STRUCTURAL CALCULATIONS FOR
GLASS WALL
3621 HARBOR BOULEVARD, SUITE 225
SANTA ANA, CA

PROJECT ADDRESS: 3621 S. HARBOR BLVD		SUITE: 225		SAPIN # 10174236	
USE OF BUILDING: RESIDENTIAL <u>COMMERCIAL</u> INDUSTRIAL OTHER				2012-101250 MASTER ID#	
NATURE OF WORK: NEW ADD <u>ALTER/T.I.</u> DEMO REROOF REPAIR SIGN MISC VALUATION: \$137,891.00					
NEW/ADDITION/ALTERATION:					
1ST FL. _____ SF		BASEMENT: YES/NO _____ SF		NO. OF STORIES: 2	
2ND FL. _____ SF		PATIO/ENCL. PATIO: _____ SF		BLDG. HEIGHT: _____	
TOTAL OF OTHER FLS: _____ SF		RES. REMODEL: _____ SF		PROPOSED USE: OFFICES	
GARAGE/CARPORT: _____ SF		ALTER/T.I.: 5,486 USF (NO CHANGE TO DEMISING WALLS)			
JOB DESCRIPTION (non-residential projects see reverse side of this application): TENANT IMPROVEMENT: NEW INTERIOR WALLS, DOORS, CARD READERS, AREA OF HARDLID CEILING & 2 SOFFITS (IN 2 ROOMS ONLY), SOUND CONTROL IN 8 ROOMS, WINDOWS, MILLWORK & APPLIANCES, & FINISHES, SOME DEMO & RELOCTED ITEMS.					
BUILDING OWNER'S NAME: ARDEN REALTY (CONTACT: DYANA ELAM)				PHONE NO: (310) 966-2655

TENANT IMPROVEMENT PLAN CHECK COMMENTS

PLAN CHECK NO: 10174236 - 237

7 PARTITION BRACE DETAIL
 BRACE
 SCALE: 1-1/2" = 1'-0"

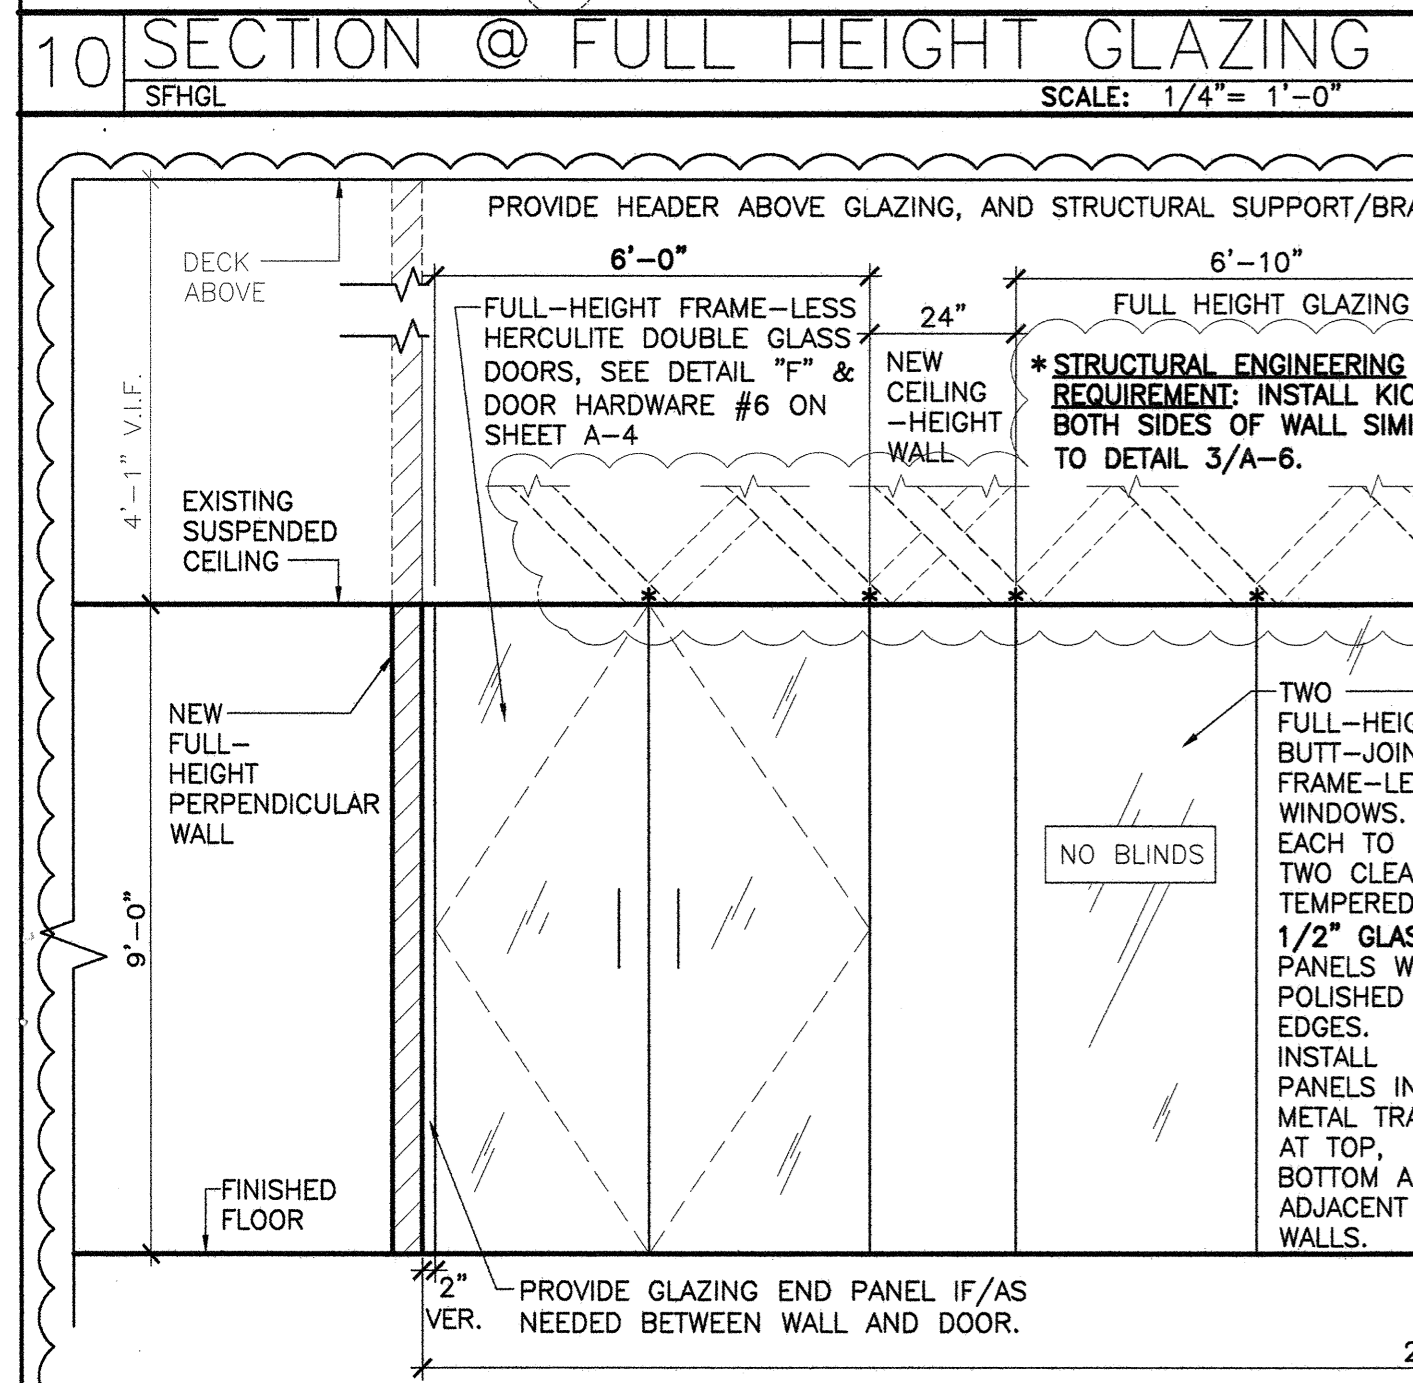
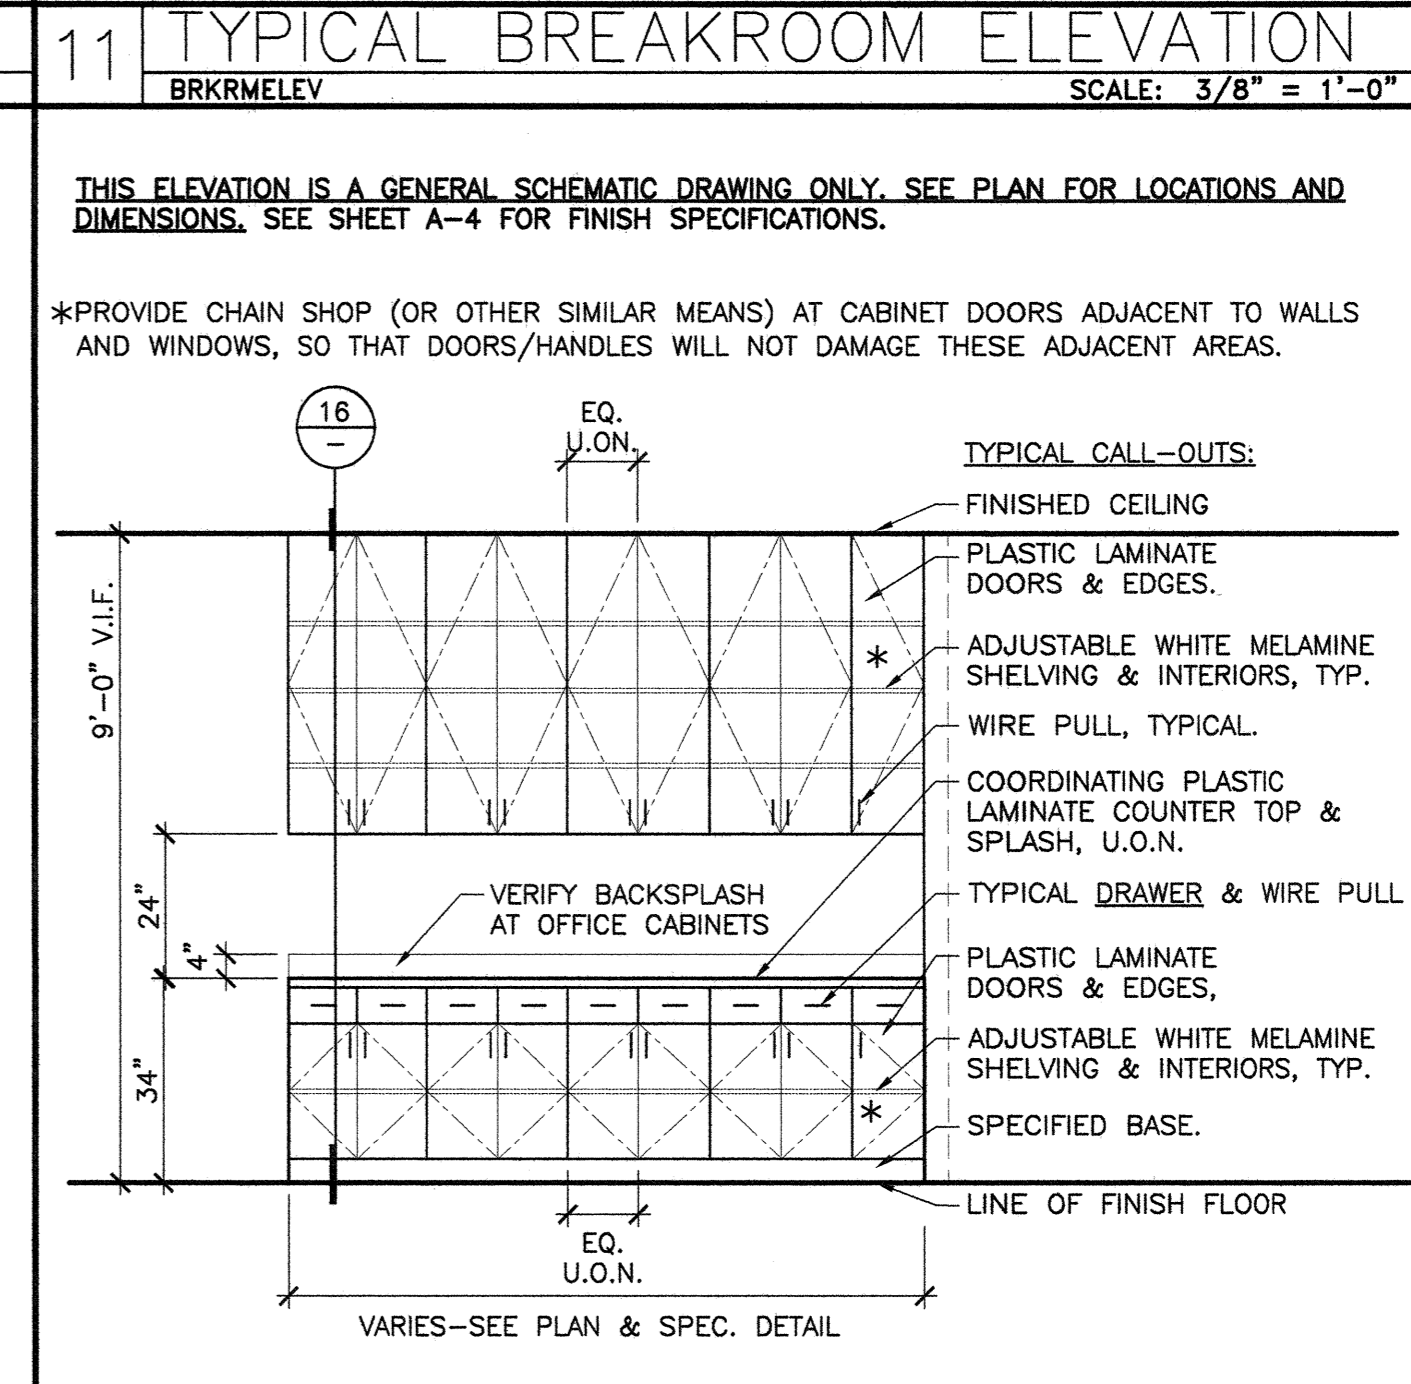
Glass shall be firmly supported on all four edges. Show on the drawings how compliance shall be made with CBC Section 2404. For glass not firmly supported on all four edges, design shall be submitted to the building official for approval. *SEE REVISED DETAILS #5, 10 & 15 ON A-6.*
